Determination 2011/067

Regarding the refusal to issue a building consent for a house with straw bale walls at 668 Manawahe Road, Whakatane

Section showing the main features of the basic construction

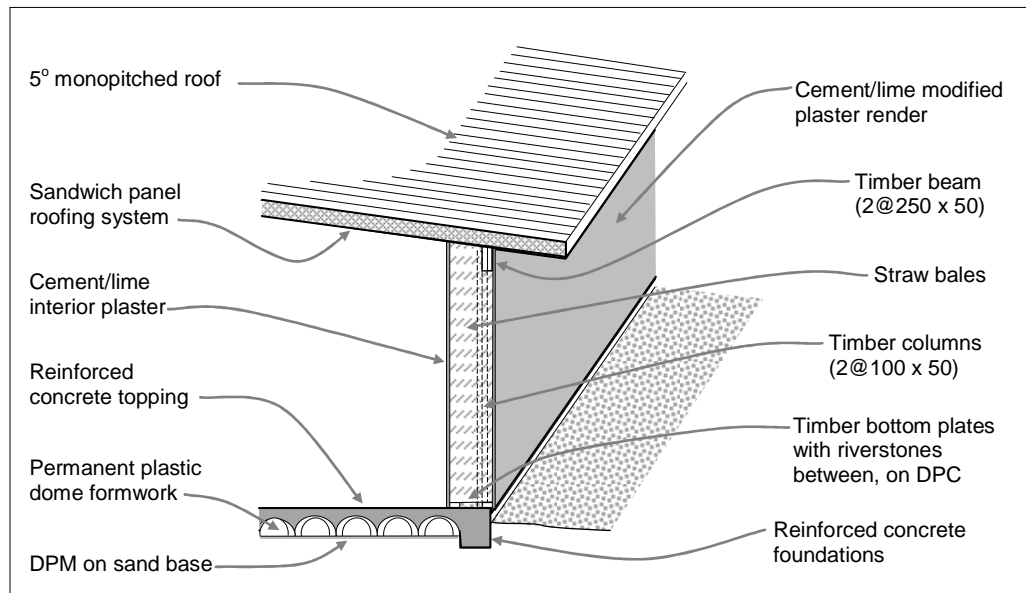
- 5.4 The specialist considered that some 'fundamental issues of weather protection to the walls and the penetration details do require serious reassessment'; and concluded that the proposed building is 'at high risk of failure with meeting the requirements' of Building Code Clauses B2, E2 and E3, noting:

- Strawbales are at risk of failure mostly from decay caused by excessive moisture. If E1, E2 and E3 details are not adequate, or roof durability is not adequate, then there is a risk of moisture induced damage, leading to failure.

- 5.5.1 The specialist noted that the set of drawings was 'very large and comprehensive', but noted some errors, missing details, inconsistencies and a general lack of cross-referencing. While some items are minor and easily remedied, others are more substantial and require addressing.
- 5.5.2 The specialist included the following comments on the drawings (in summary):
- some details are not adequately or correctly labelled/titled and/or not cross-referenced to locations
 - roof overhangs are not dimensioned and are inconsistent when scaled

- paint coatings must be specified, as it is important that coatings do not provide vapour barriers that reduce the ‘breathability’ of the straw bale walls

- it is not clear whether control joints are proposed
- there are no details of junctions at the pool feature, where bales on flat meet bales on edge on one side and 140mm thick straw on the other side (the designers have since signalled their intention to remove the pool feature)

- it is not clear how straw bales are to be laced and pinned under the roof
- the netting around the straw bales is shown in the first scratch coat of the plaster, whereas plaster reinforcing mesh must be within the second coat

- there are no details of jamb to sill flashing junctions, window seals and additional reinforcing mesh at corners of the plaster (the designer has offered to provide a 3D sketch if requested by the authority)

- there are no details of junctions between bathroom fixtures and straw bale walls
- while bottom plates are noted as H3, the proposed treatment of timber posts and beams within the straw bale walls is unclear

- mulseal over the footings is noted on some drawings but not shown on others
- as E2/AS1 window details do not apply to straw bale walls, flashing dimensions should be shown on drawings

- flashings at wall to soffit junctions are shown in some drawings but not others
- the running of water pipes through straw bale walls need to be expressly prohibited, due to the risks of plumbing leaks and/or condensation moisture
